SERVICE BULLETIN

This service bulletin has been revised to add pricing data to the options available in the modification of the P/N 60-703xx(x) and 60-723xx series of pump housing subassemblies. Please replace the existing service bulletin in its entirety.

Bulletin No. 60-703-28-34
Revision 1, 2000/11/20
H/A 8-160 & 8-272
ATA 28-31

FUEL – MODIFICATION OF FUEL OVERRIDE JETTISON PUMP HOUSING SUBASSEMBLIES PART NO. 60-703200, 60-70304, 60-70305, 60-703135 (BOEING PART NO. [BPN] 60B92603-21, -2, -5, -20), AND PART NO. 60-703200-1, 60-70304-1, 60-70305-1, 60-703135-1 (BPN 60B92603-25, -102, -105, -120), USED ON 747 / 747-400 AIRCRAFT.

**Typical Pump Housing
Figure 1**

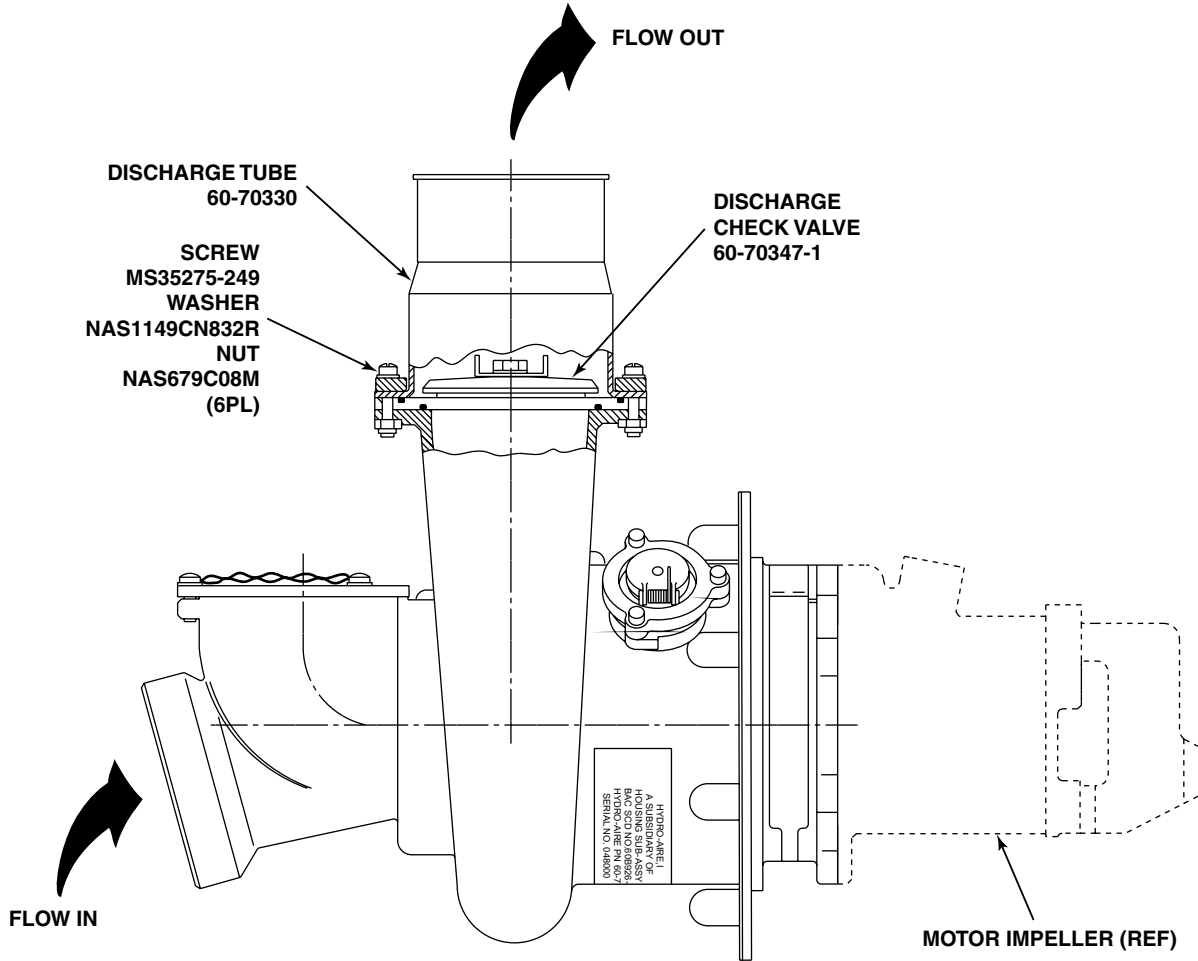
Product Improvement: The discharge check valve design has been changed to increase its structural integrity.

This service bulletin gives instructions for the modification of Hydro-Aire Fuel Override/Jettison Pump Housing Subassemblies shown in paragraph 1.A. with a new discharge check valve assembly, P/N 60-70347-1, and washers, P/N NAS1149CN832R (see Figure 1).

- (1) Refer to the DISASSEMBLY section in the applicable reference shown in paragraph 1.J. and remove the P/N 60-70330 discharge tube, P/N 60-70356 discharge ring, and P/N 60-70347 discharge check valve assembly from the P/N 60-703200, 60-70304, 60-70305, 60-703135, 60-703200-1, 60-70304-1, 60-70305-1, or 60-703135-1 housing subassembly.
- (2) Put new P/N MS29513-143 packing on lower mating surface of new P/N 60-70347-1 discharge check valve assembly (see Figure 2).
- (3) Position the P/N 60-70356 discharge tube ring over the P/N 60-70330 discharge tube and place new P/N 60-70354 packing, P/N 60-70347-1 discharge check valve assembly, and P/N 29513-143 packing (Figure 2) on the P/N 60-703200, 60-70304, 60-70305, 60-703135, 60-703200-1, 60-70304-1, 60-70305-1, or 60-703135-1 housing subassembly where shown on Figure 1.

**Discharge Check Valve Assembly
Figure 2**

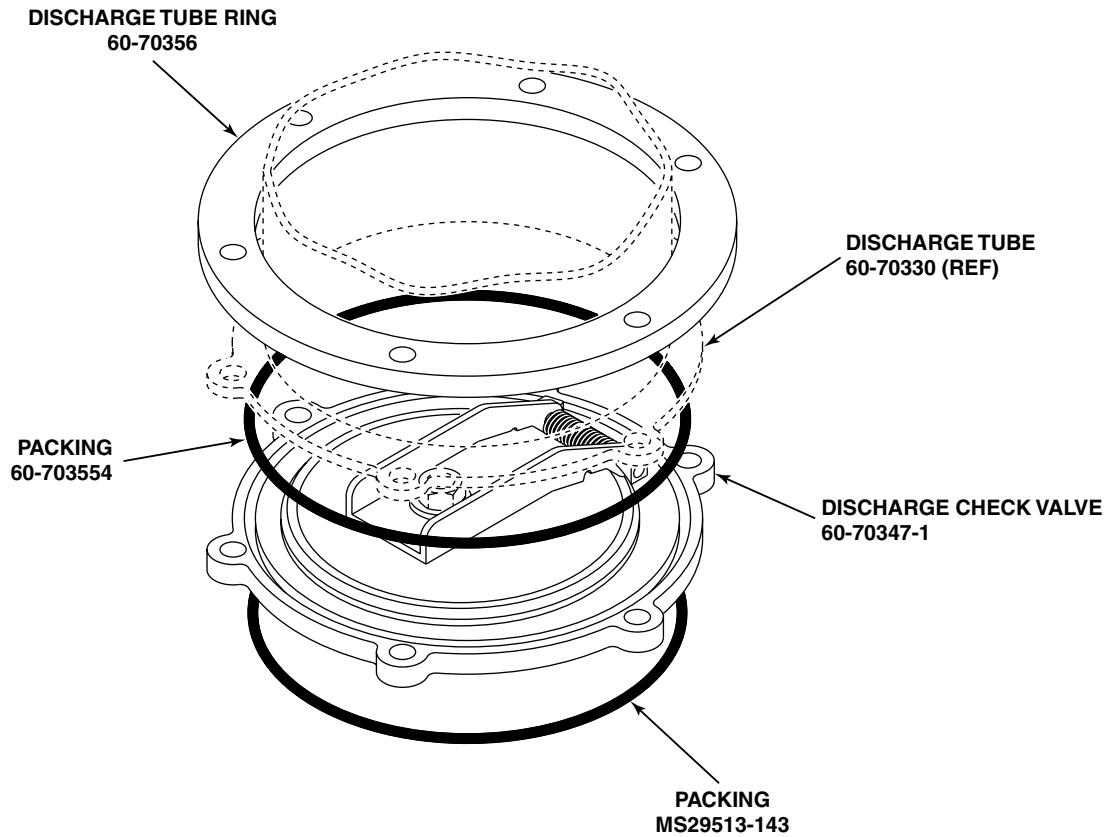
NOTE: Discharge check valve and discharge tube ring hole patterns will only align one way.

- (4) Use six P/N MS 35275-249 screws, NAS1149CN832R washers, and NAS679C08M nuts to attach P/N 60-70356 discharge ring, 60-70330 discharge tube, 60-70354 packing, 60-70347-1 discharge check valve, and MS29513-143 packing to a P/N 60-703200,

- (5) Torque P/N MS35275-249 screws to 17–19 in-lb (1.92–2.15 N²m).
